Division 5.2 and EPBC Act Approval

Modification Assessment

**The Northern Road Upgrade – Mersey Road,
Bringelly to Glenmore Parkway, Glenmore Park**

December 2018

Figure 2-1 Overview of proposed changes for the project

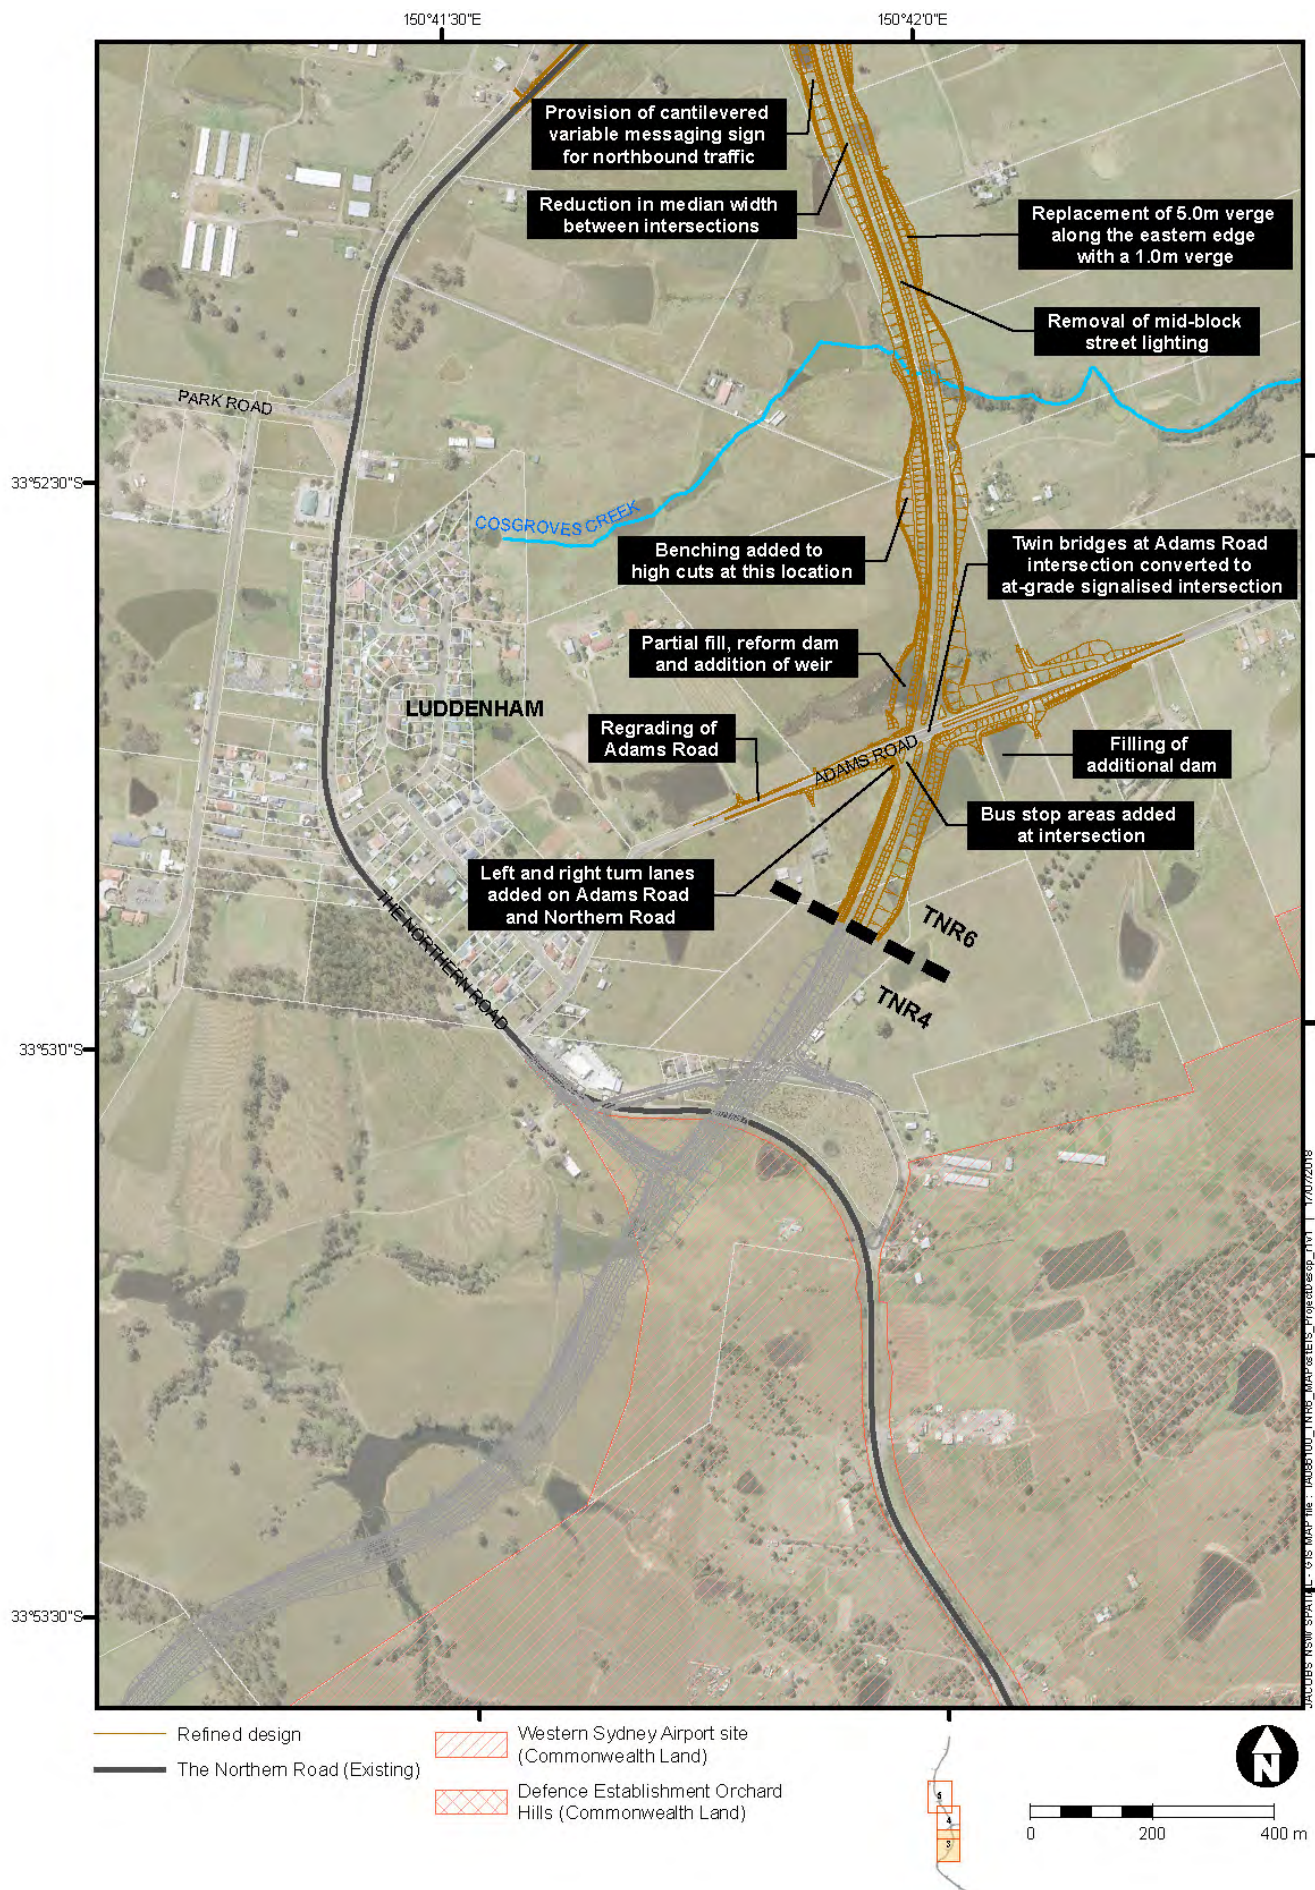
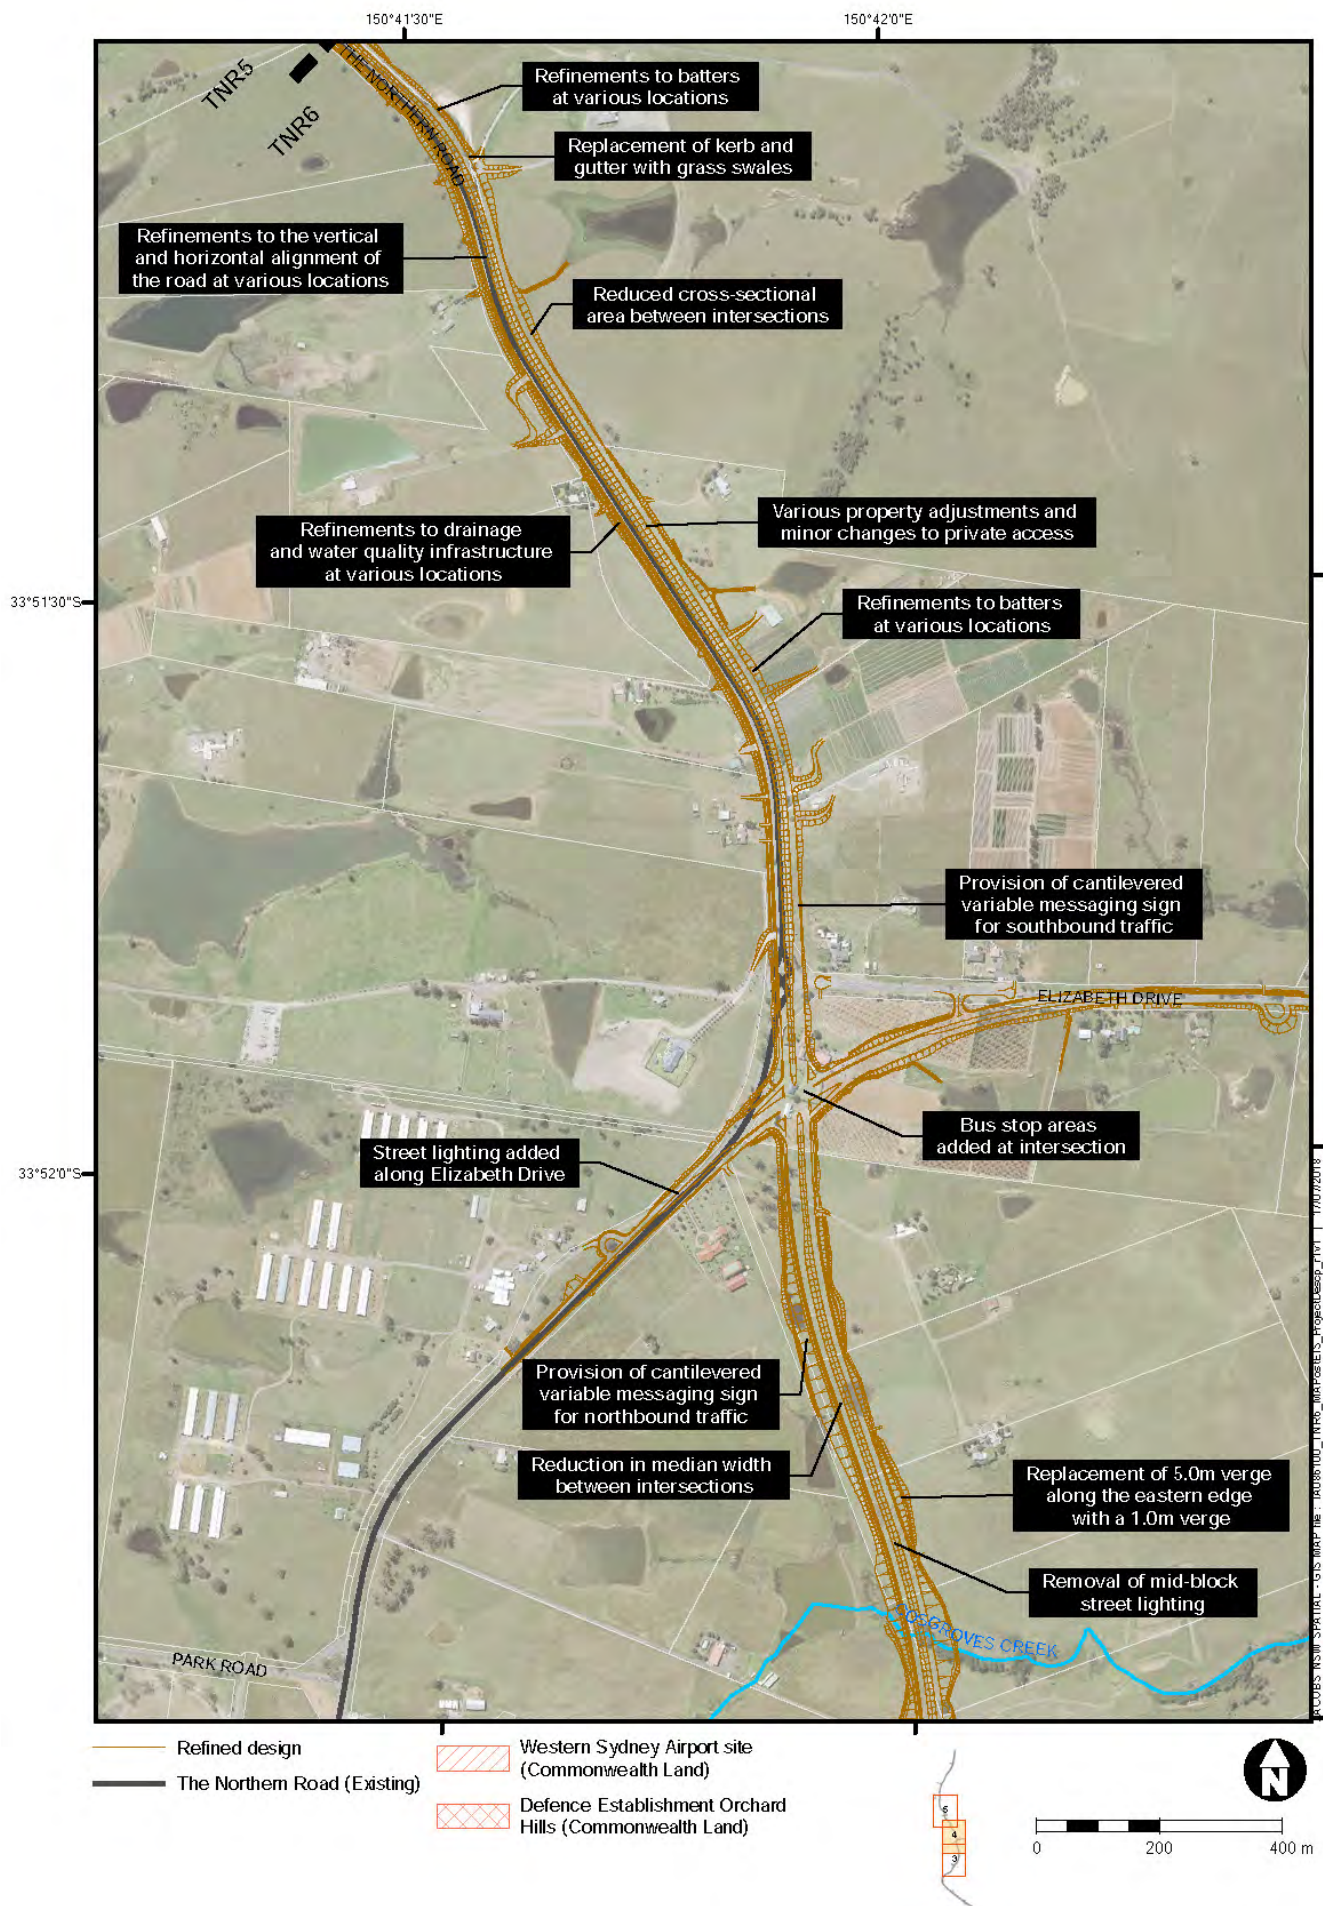
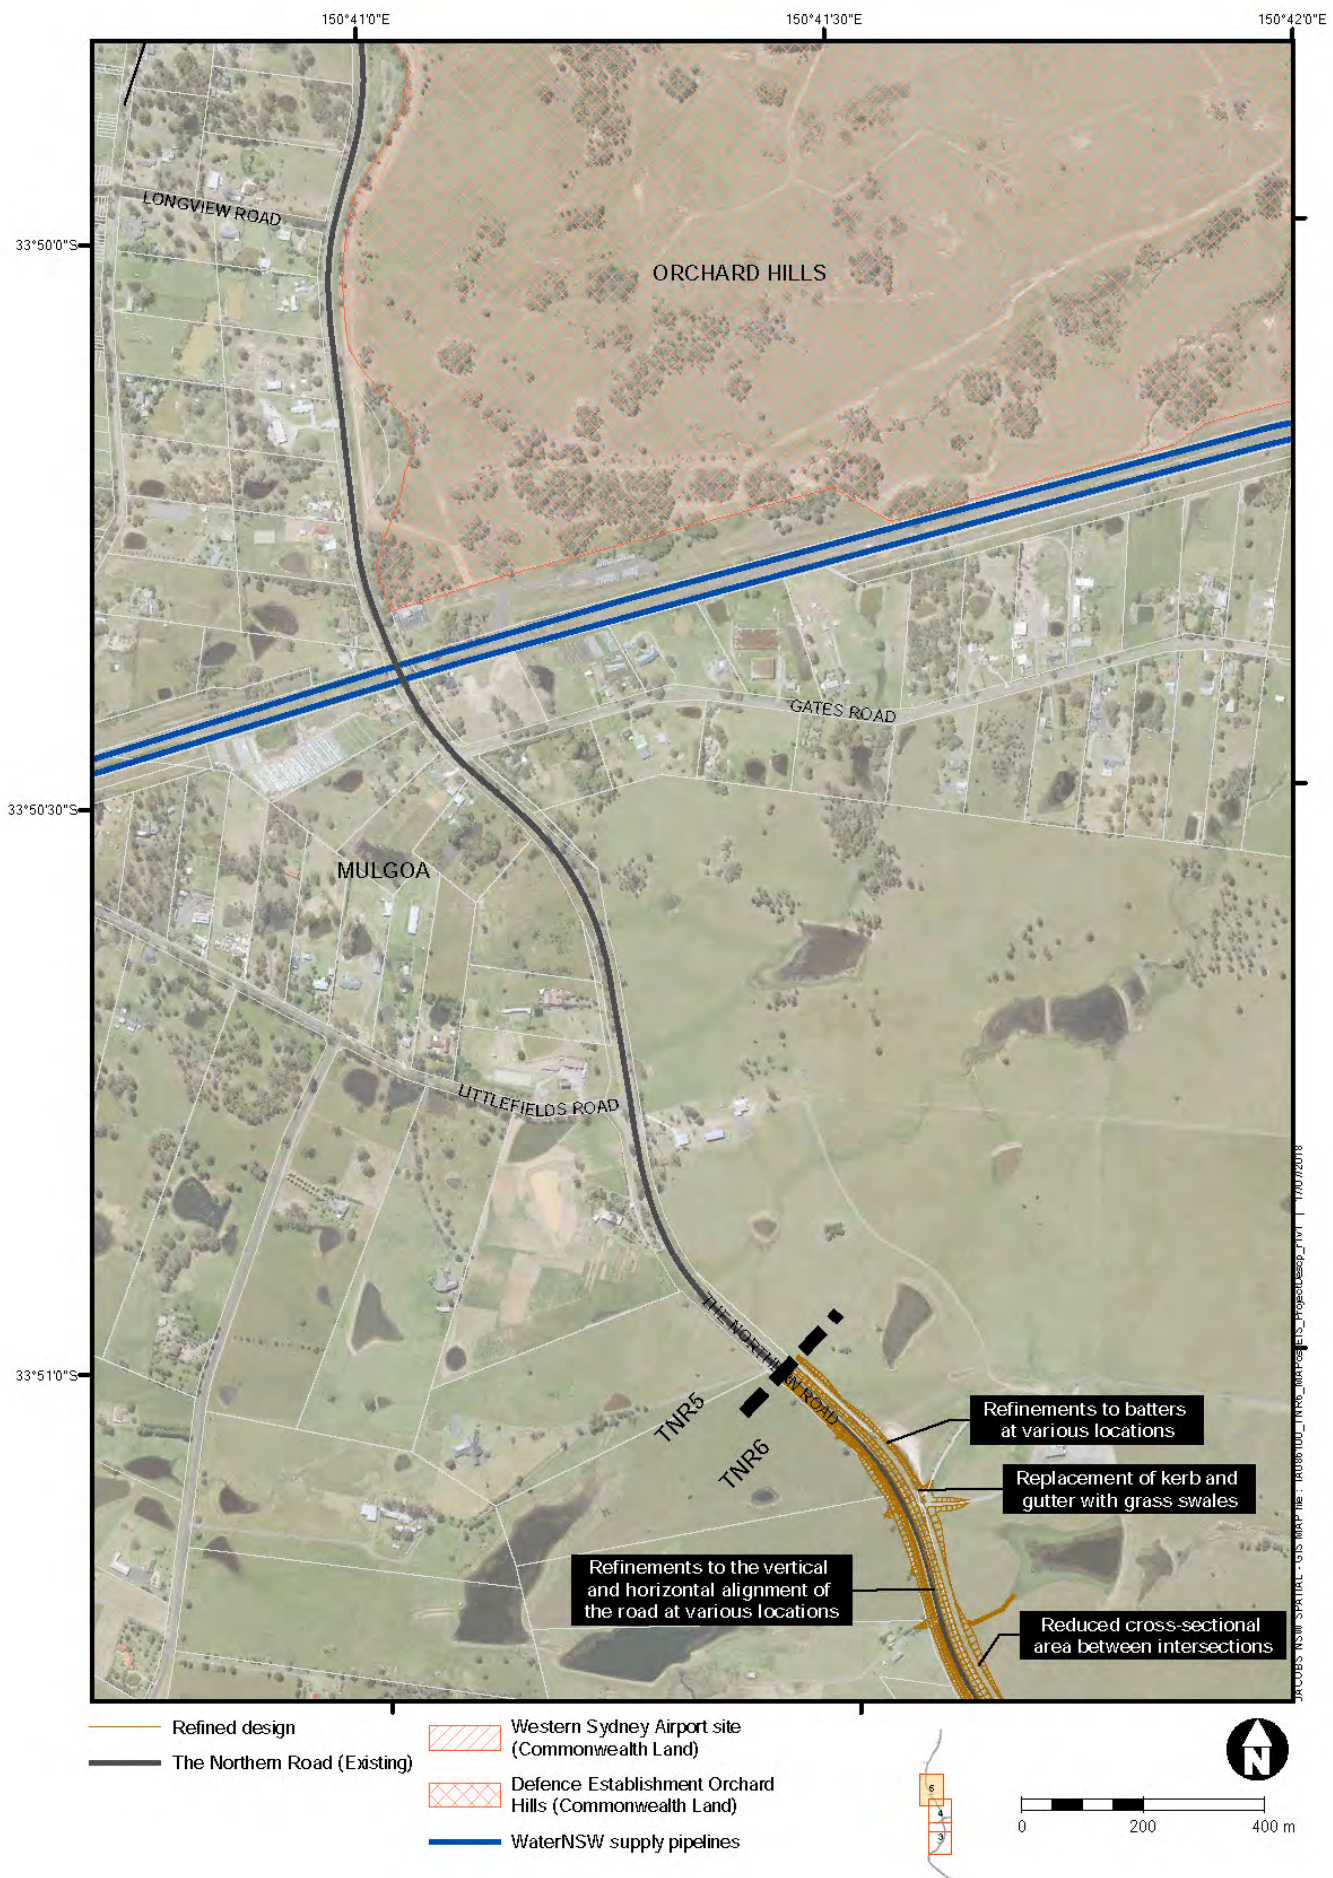
Roads and Maritime proposes to modify the Minister's approval for Stage 6 of the project to replace the approved twin bridges over Adams Road with an at-grade signalised intersection.

Roads and Maritime has made minor changes to the approved project, in addition to those described in Section 2.2. These changes are also shown on **Figure 2-1** and include:

- Replace kerb and gutter with grass swale, except at footpath locations near Adams Road and Elizabeth Drive intersections
- Changes to drainage structures (pit, pipes, culverts, swales) to suit horizontal and vertical geometry

- Cut and fill batter slopes revised from 1:4 to 1:3 in most places. Benching added to high cuts between chainage 6320 – 6620
- Removal of street lighting mid-block

- Street lighting added for turning heads along Elizabeth Drive
- Bus stop areas added on north-bound and south-bound lanes at Adams Road and Elizabeth Drive intersections
